Application No. : 10/810,184

Remarks:

ANNOTATED MArked-UP COPY of Drawing

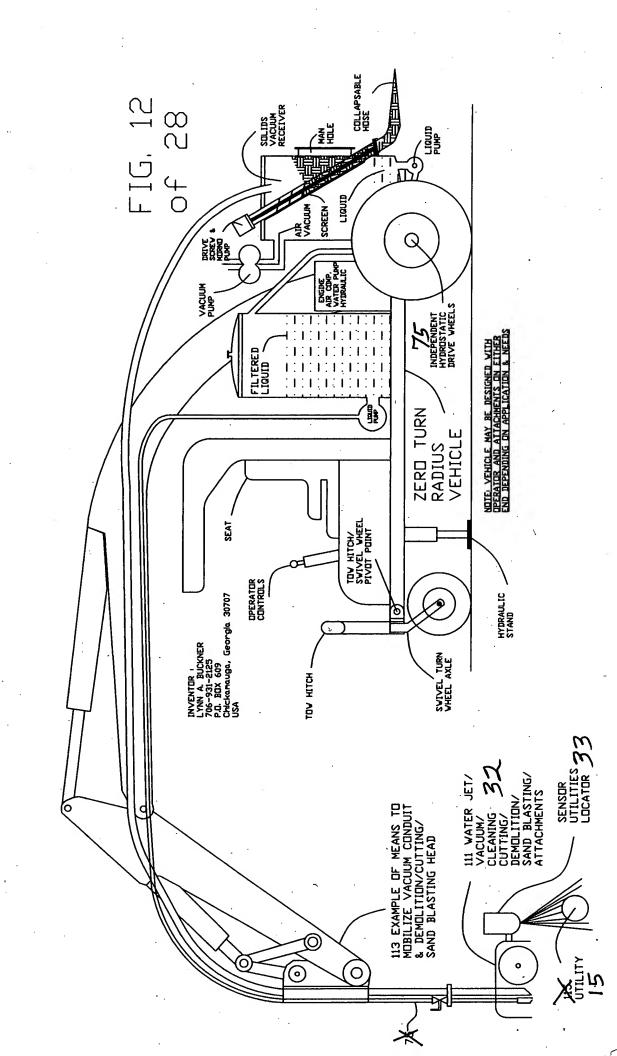
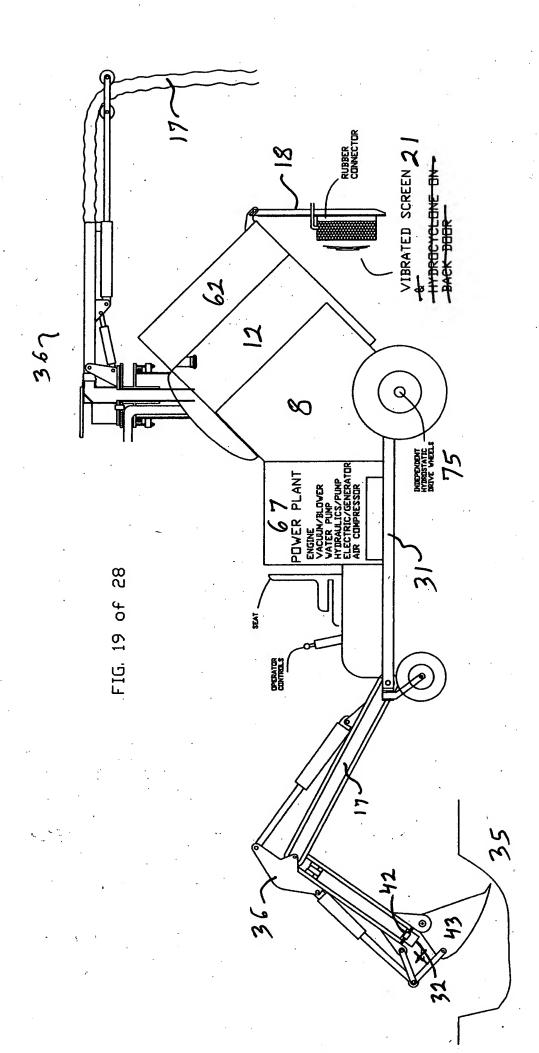
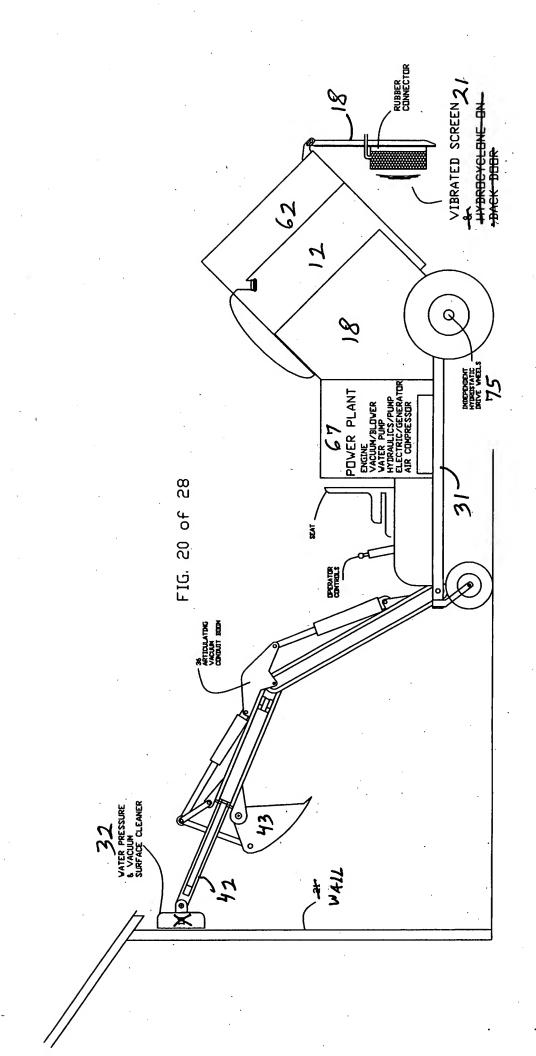
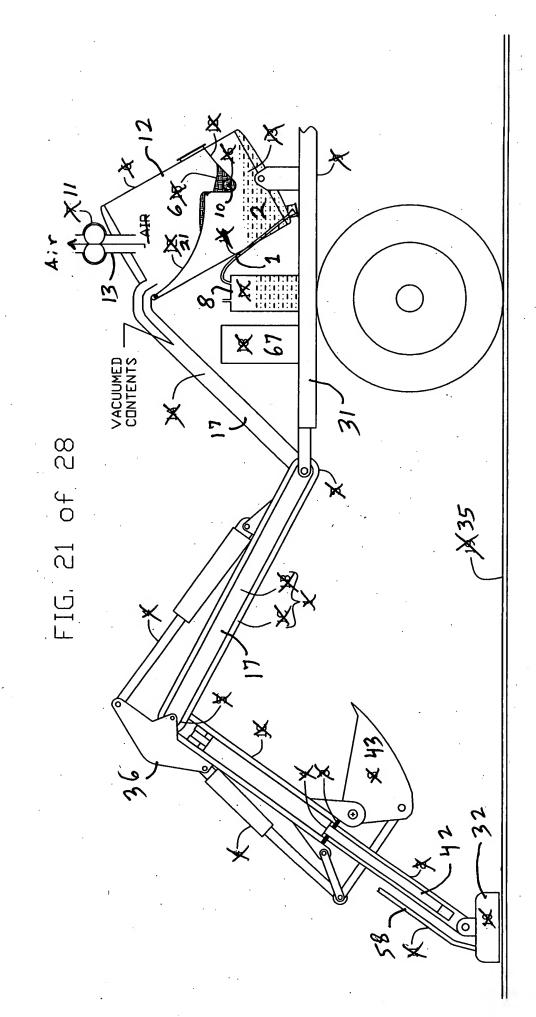
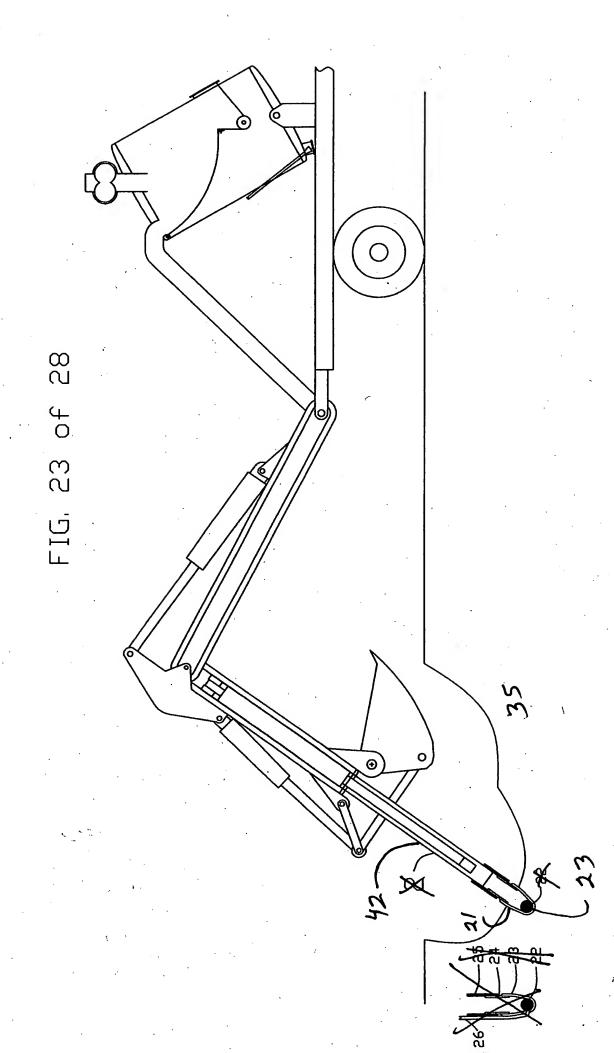
Please amend drawings # 6, # 9, # 12, # 19, # 20, # 21, and # 23

Each of the above mentioned drawings to be amended have a corresponding attached drawing marked "Annotated Marked-up Drawing" and a clean drawing marked "Replacement Sheet".
